LONGITUDINAL SECTION AND DECKS

APPROVED for 998P
LLOYD'S REGISTER OF SHIPPING

Messrs. A. & J. Inglis & Co

Yard 10988 P. / 998 P

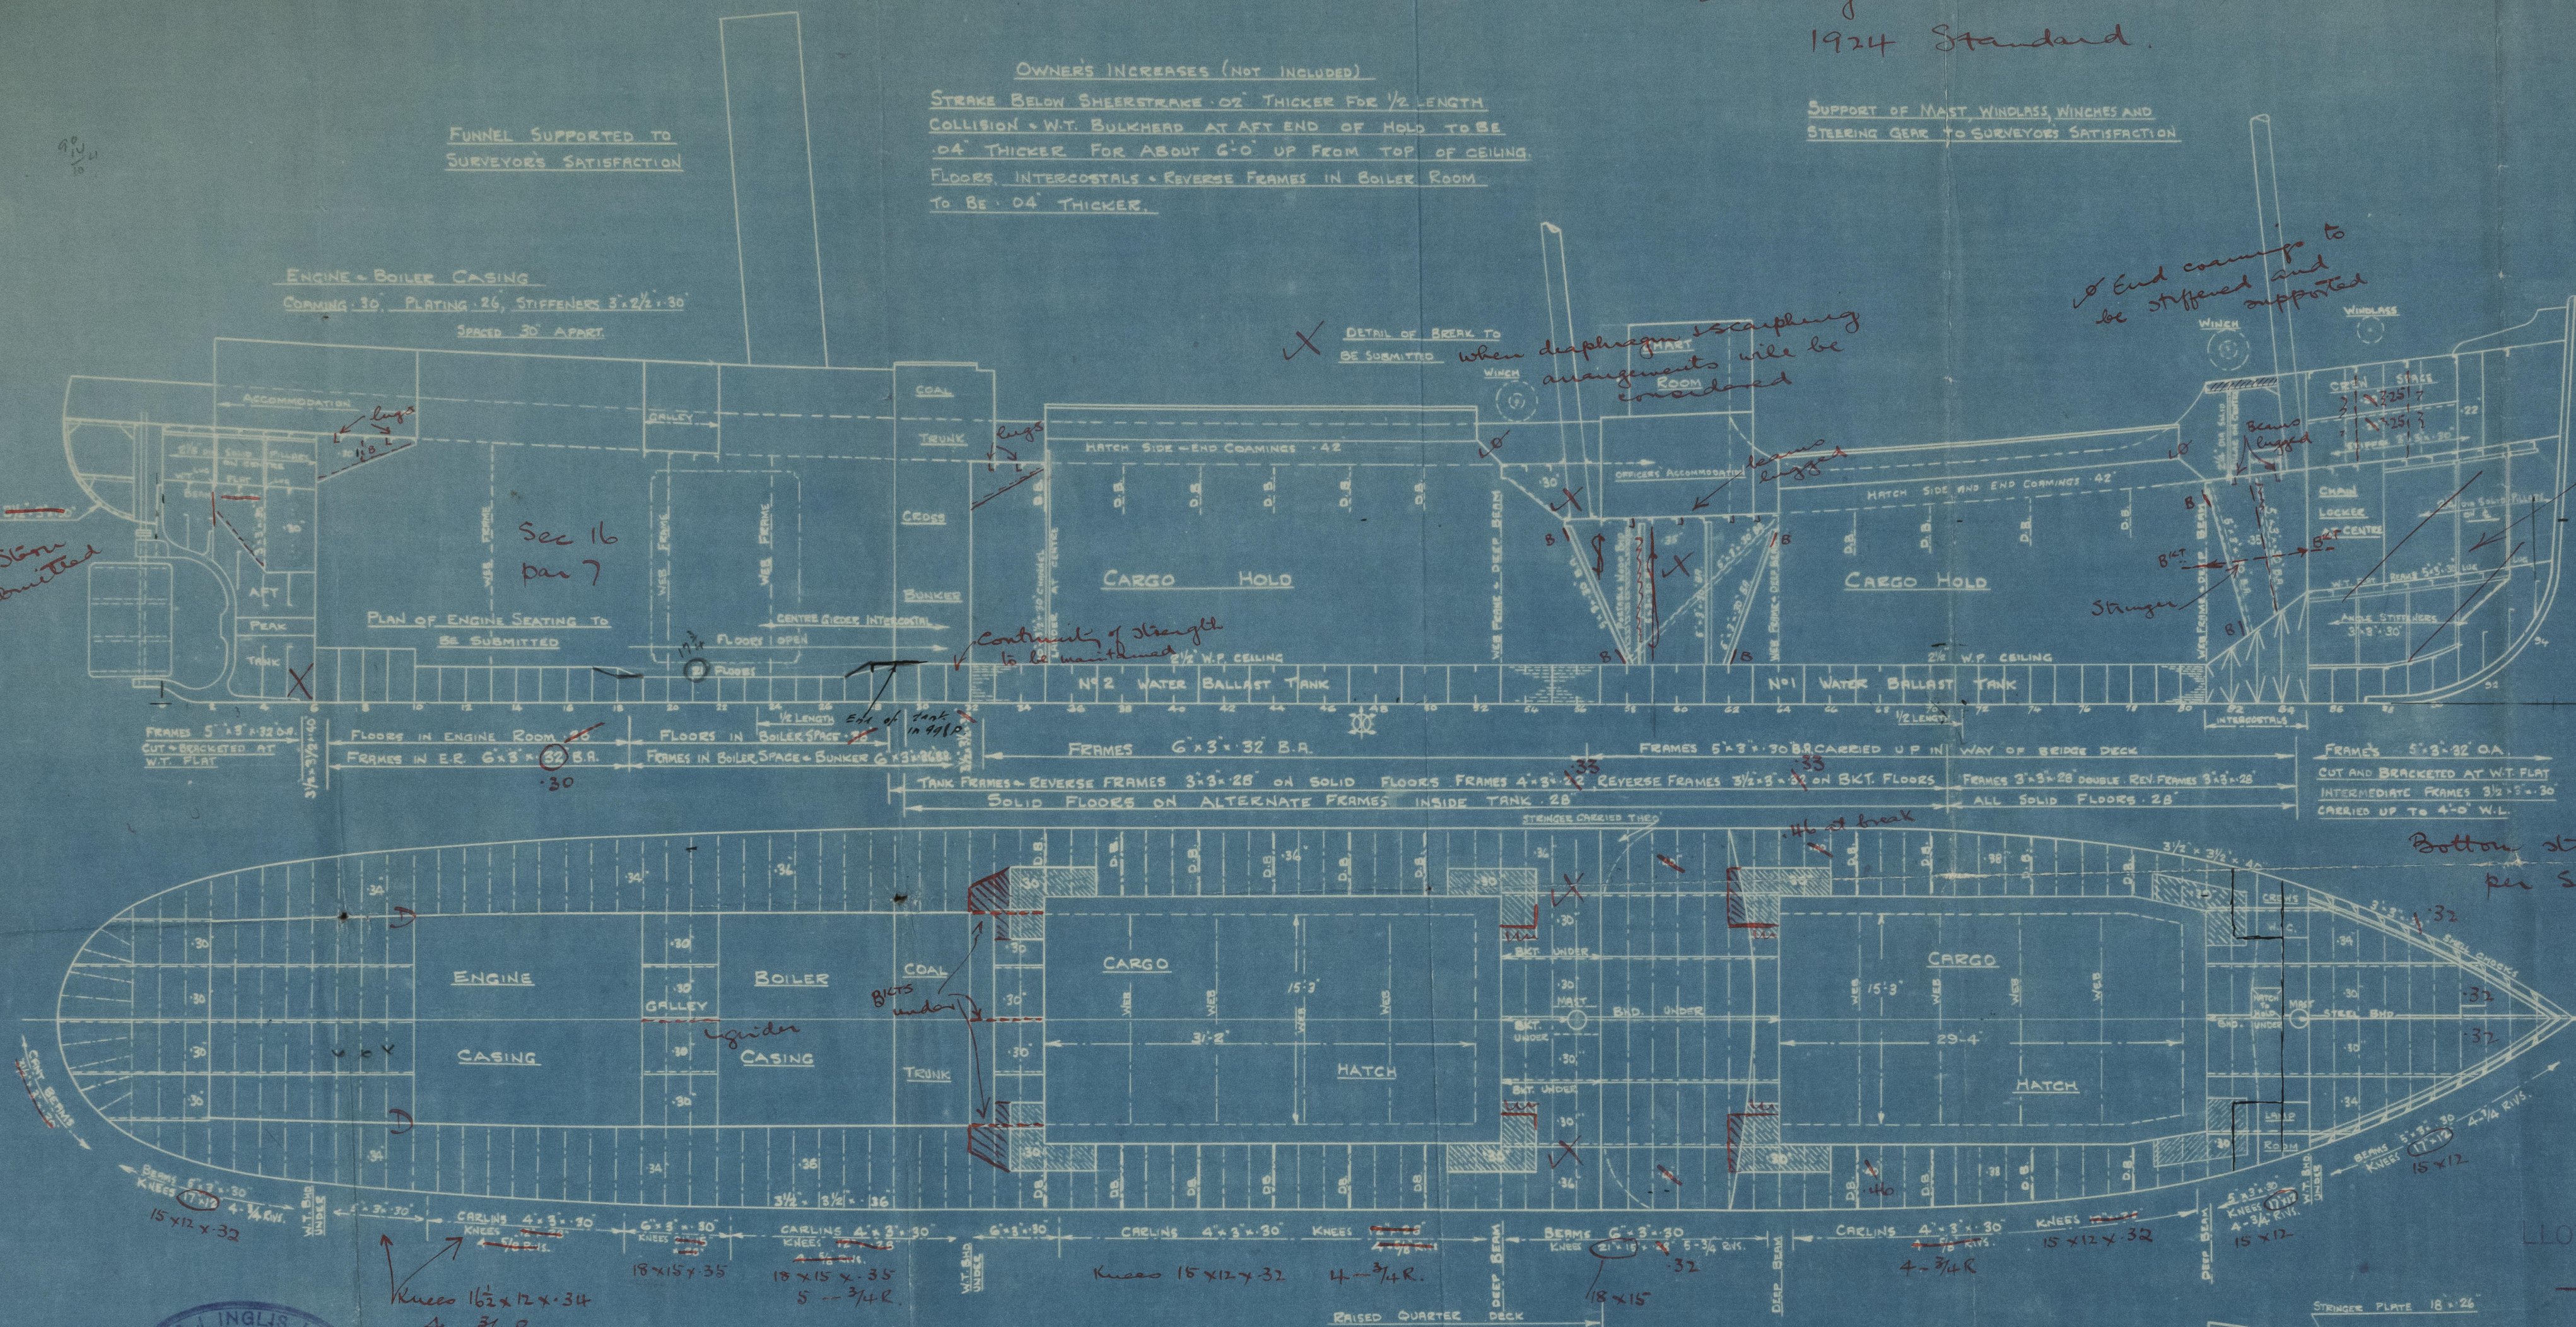
Bull angles assumed
1924 Standard.

FUNNEL SUPPORTED TO
SURVEYORS SATISFACTION

OWNERS INCREASES (NOT INCLUDED)
STEAKS BELOW SHEERSTRAKE .02" THICKER FOR 1/2 LENGTH
COLLISION W.T. BULKHEAD AT AFT END OF HOLD TO BE
.04" THICKER FOR ABOUT 6'0" UP FROM TOP OF CEILING
FLOORS, INTERCOSTALS & REVERSE FRAMES IN BOILER ROOM
TO BE .04" THICKER.

SUPPORT OF MAST, WINDLASS, WINCHES AND
STEERING GEAR TO SURVEYORS SATISFACTION

DETAIL OF BREAK TO
BE SUBMITTED

when diaphragm
arrangements will be
considered

End coamings to
be stiffened and
supported

FORE END STIFFENING
TO BE SUBMITTED

When arrangements
will be considered

Common Store
to be submitted

Sec 16
par 7

Continuity of strength
to be maintained w.p. ceiling

Bottom strengthening as
per Sec 11
